BBK AV ELECTRONICS CORP., LTD.			
Title AV BOARD			
Size	Document Number		Rev
	7DW9917-0		1.0
Date:	Friday, September 16, 2005		Sheet 2 of 10

Title <Title>		
Size A	Document Number <Doc>	Rev <RevCode>
Date:	Friday, September 16, 2005	Sheet 1 of 10

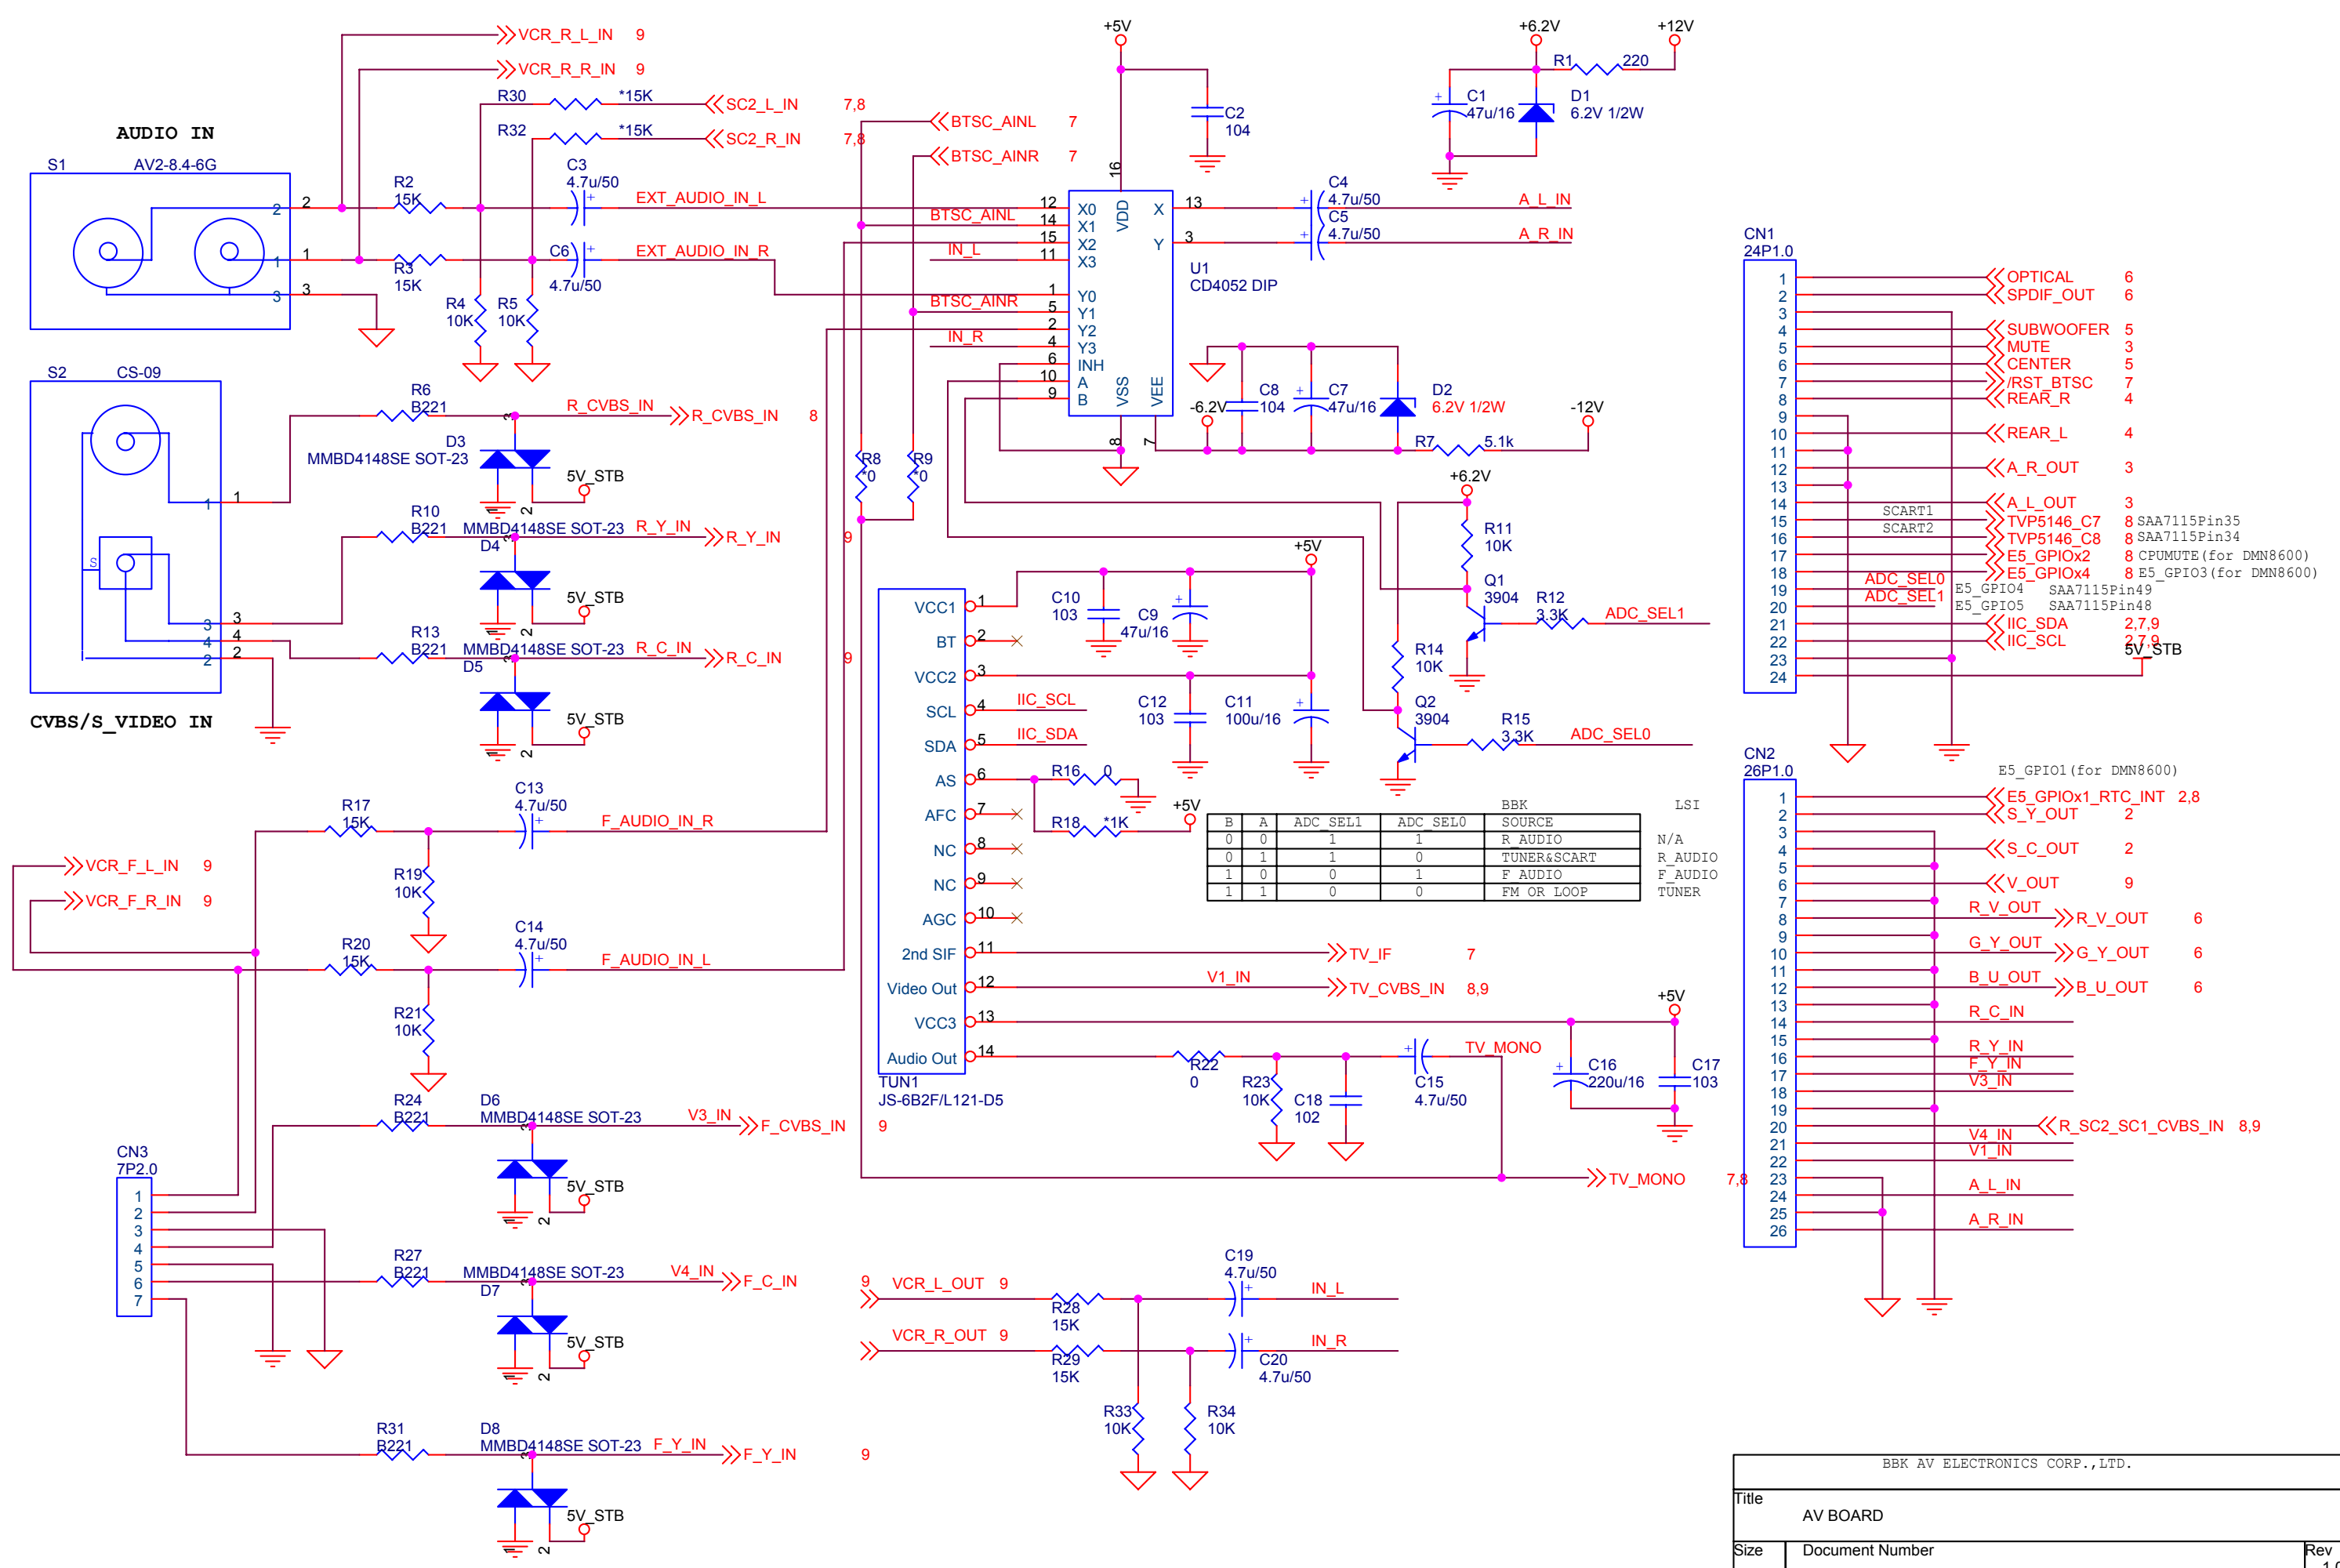
A		B		C		D		E	
Modify Notes:									
2005.01.08									
P1 U1 Supply voltage from +6.2V to +5V									
P8 Del Net E5_C									
P8 Add C166,C167,C168 when in mtk scart and out scart(rgb) ,exist interference.									
P7. add gcode ic									
P9. add r210,r211,r213,r214 amend the sound distortion when playing vcd,sterio out,connect KONGJA tv									
P8 add c169,c176 amend log picture distortion									
2005.01.12									
P8 add Q39,Q40,r218,r219,r220 etc. switch RGB/CVBS select votage level,when SCART in									
2005.01.28									
change c136,c145 to 220u									
</
